LANEY COLLEGE CHILDCARE CENTER RENOVATION

BID NO. 18-19/09

ADDENDUM No. 2

Clarification on RFI During Job Walk

8' HIGH COMMERCIAL TOP GUARD ORN IRON
 2-1/2" SQ POSTS-1-1/2" RAILS-3/4" PICKETS

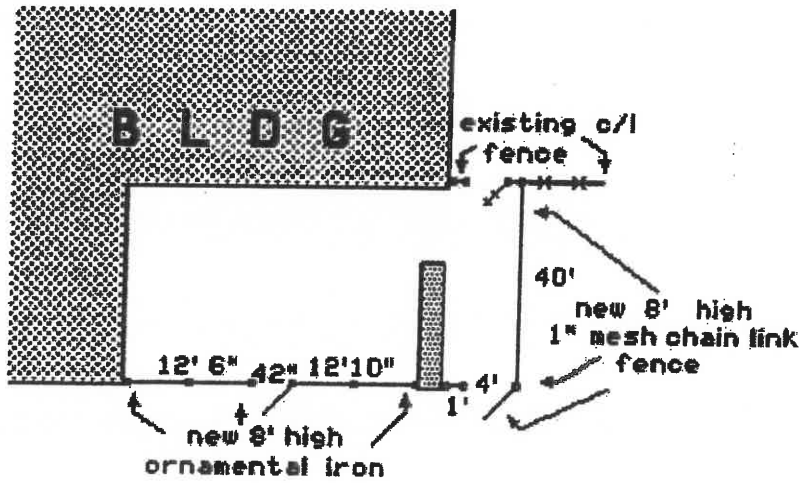
1. **FENCE** – Fence work in the initial BID advertisement has been replaced with (I) Ornamental iron fence (30Lf of 8ft height, curved top, pressed point ornamental iron with I each gate that measures 42in wide by 7ft high). (II) Chain Link Fence of approximately 41Lf and 8ft high galvanized 1inch mesh, with 1 each 4ft wide by 8ft high Pedestrian gate. SEE SKETCH.
